SERVICE BULLETIN

NUMBER: 02-166-17
DATE: 03/10/17

SUBJECT: Upper Oil Pan Assembly- Design Changes

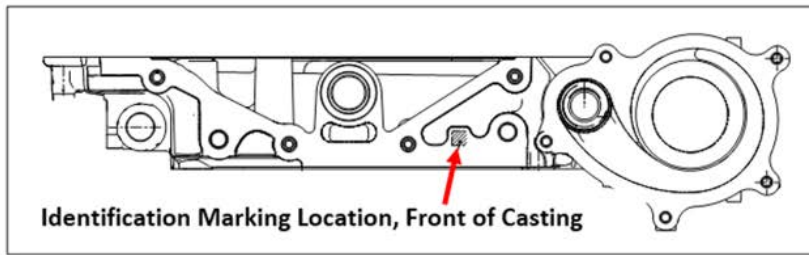
- The mating flange thickness of the casting in the area identified as the cause for the seepage has been increased by 5.5mm. (See images provided in the Parts Information section below.) This thickness increase creates the need for a longer bolt to provide proper tightening and retention.
- An additional mounting point has been added to the ribbing inside the casting to increase retention of the steel baffle plate and eliminate vibration.

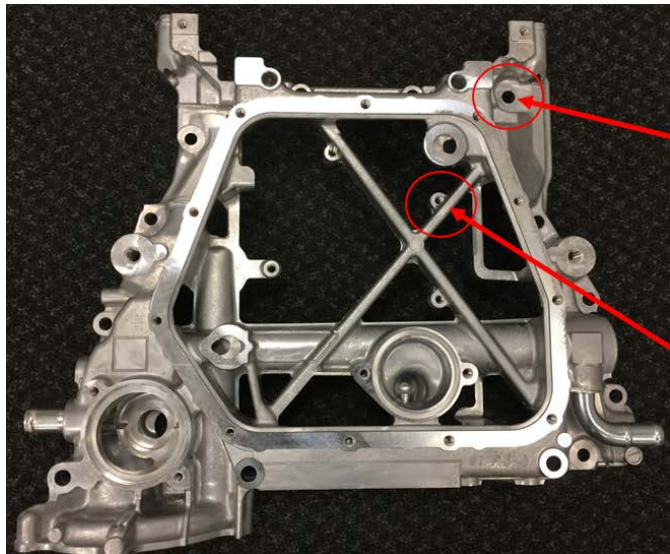
- An underscore has been added to the identification letter found on the front face next to the water pump cavity and QR code box.

- Thicker casting and an additional mounting point for the baffle plate added to the internal ribbing.

Because the thickness of the casting has been increased by 5.5mm in this area, a new, longer socket-head cap screw, p.n. 800408250 is required replacing the original hex head bolt.

An additional mounting point / bolt hole has been incorporated here to improve retention of the baffle plate. Use hex bolt p.n. 808206010.
